Environmental Minor Project Refinement Form

Project Name: West of Devers Upgrade **Request Prepared By:** Sylvia Granados

Project Date Approval Required: 6/9/2020 **Variance Request No.:** 37

Southern California Edison
West of Devers Upgrade Project
Proposed Scour Protection Areas
MPR #37

6N43

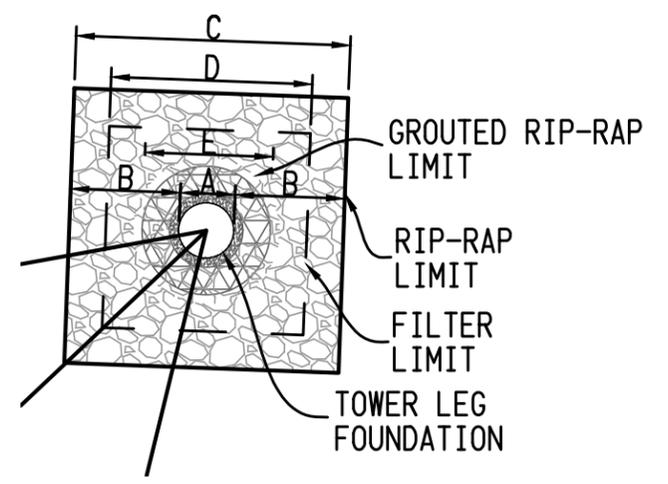
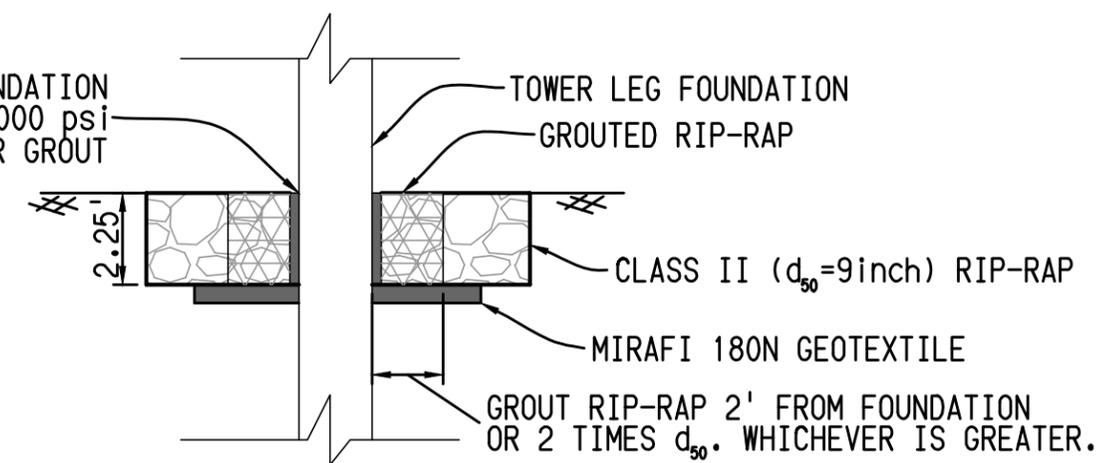
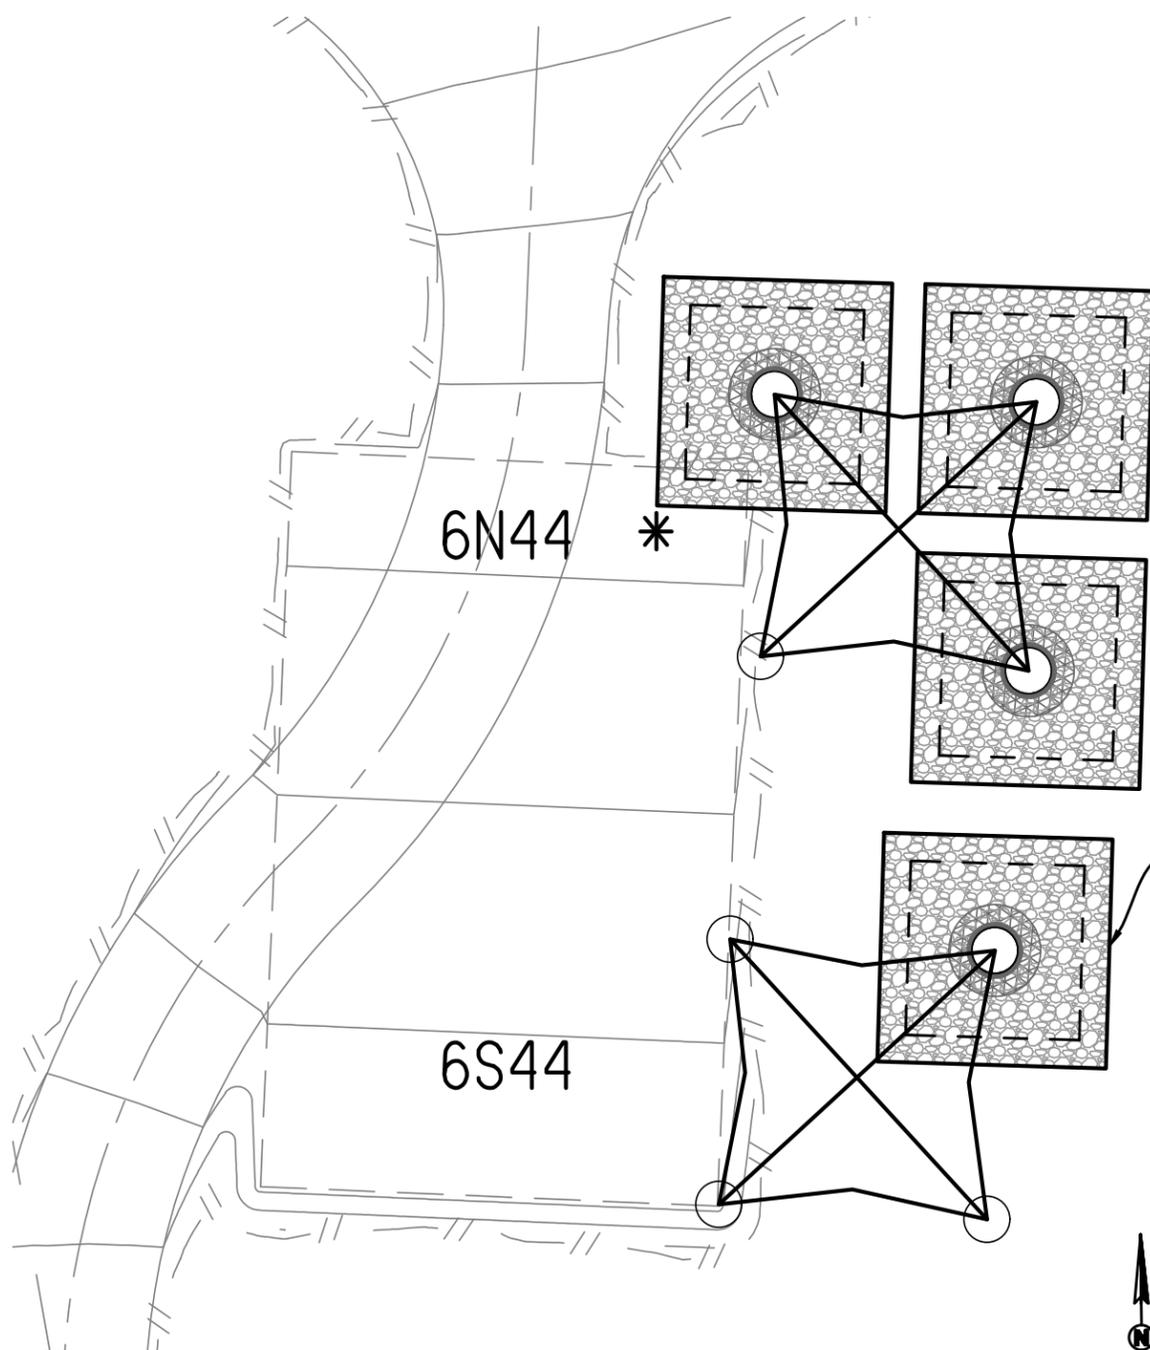
6N43 - Due to the proximity of a wash east of the tower site, the northeast tower foundation of Tower 6N43 requires construction of the countermeasures recommended in the Scour Analysis. The permanent impacts associated with these countermeasures total 0.005-acre of the previously approved disturbed tower pad area. See Figure 1, page 4 and Scour Analysis Appendix B attached for details.

FILL GAPS BETWEEN FOUNDATION
AND RIP-RAP WITH 4,000 psi
CONCRETE OR GROUT

6N44 & 6S44

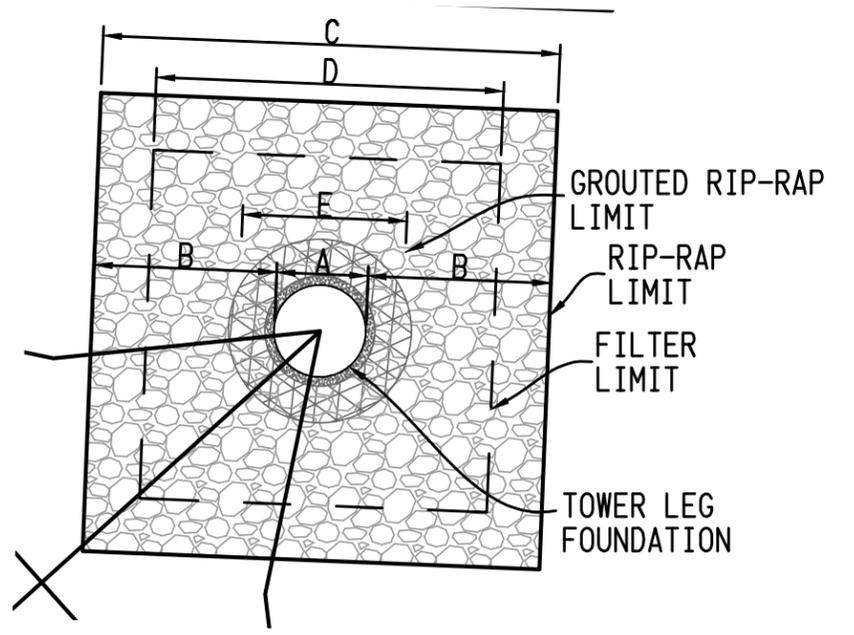
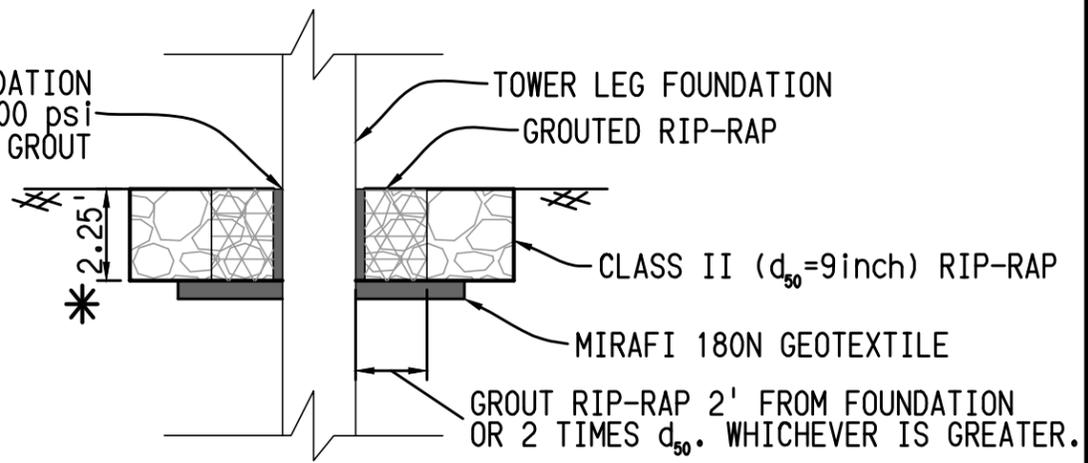
* FOR 6N44 NORTH-WEST TOWER LEG,
BURY RIP-RAP WITH 2-FOOT OF COVER TO MAINTAIN
ACCESS ACROSS PAD. DEPTH TO BOTTOM OF
RIP-RAP EQUAL TO 4.25'.

FILL GAPS BETWEEN FOUNDATION
AND RIP-RAP WITH 4,000 psi
CONCRETE OR GROUT
